Project	IEEE 802.16 Broadband Wireless Access Working Group < http://ieee802.org/16 >
Title	Sounding region allocation clarifications
Date Submitted	2006-05-04
Source(s)	Mike Hart mike.hart@uk.fujitsu.com Michiharu Nakamura Miyoshi Saito Kobayashi Hiroki Fujitsu
Re:	IEEE 802.16e-2005 & comment submitted to the IEEE802.16 #43 maintenance session
Abstract	Proposes modifications to clarify the issue of sounding region allocation
Purpose	Adopt changes
Notice	This document has been prepared to assist IEEE 802.16. It is offered as a basis for discussion and is not binding on the contributing individual(s) or organization(s). The material in this document is subject to change in form and content after further study. The contributor(s) reserve(s) the right to add, amend or withdraw material contained herein.
Release	The contributor grants a free, irrevocable license to the IEEE to incorporate material contained in this contribution, and any modifications thereof, in the creation of an IEEE Standards publication; to copyright in the IEEE's name any IEEE Standards publication even though it may include portions of this contribution; and at the IEEE's sole discretion to permit others to repro

Figure 222b – Example of correct rectangular allocations for the sounding region.

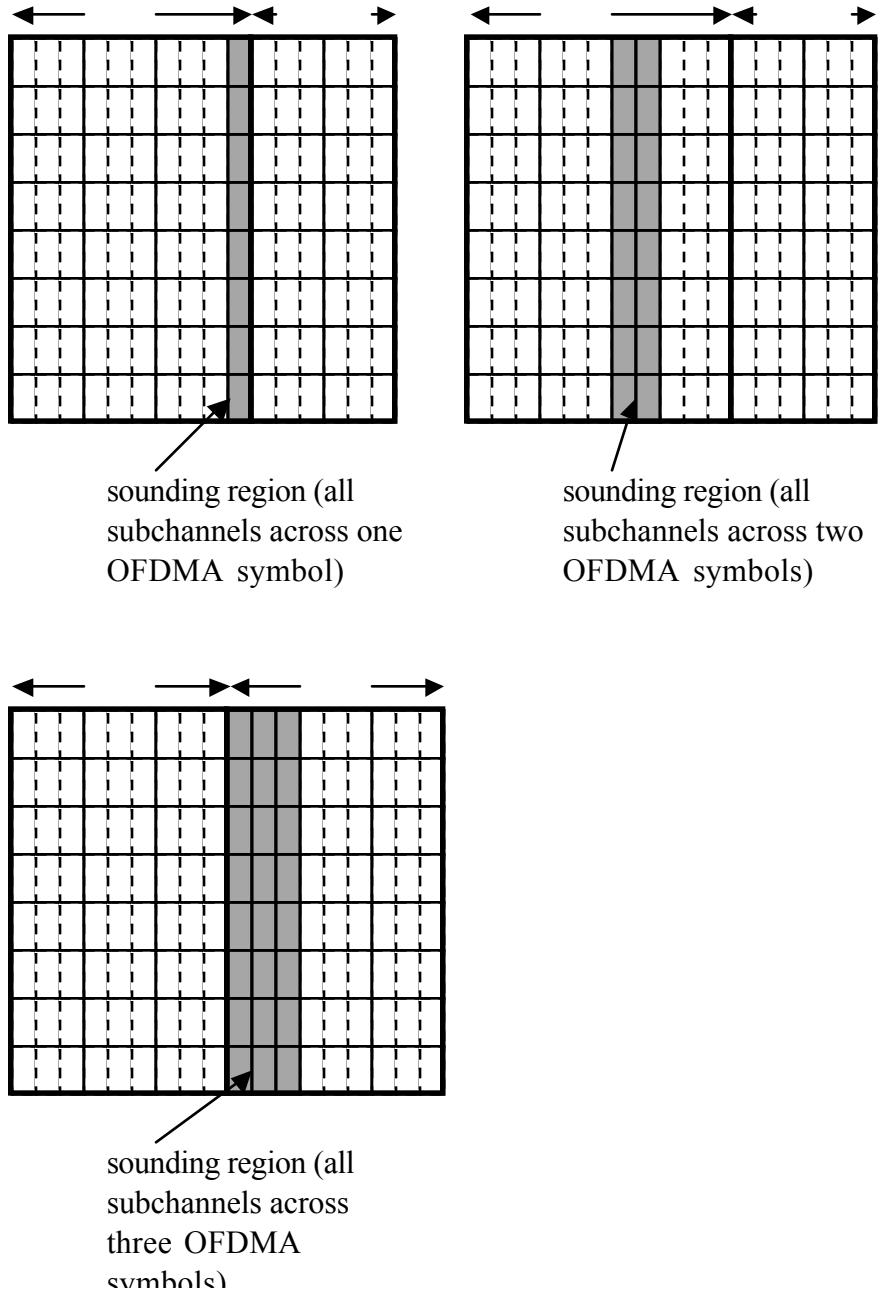
[Insert Figures 222b and 222c after Figure 222a:]
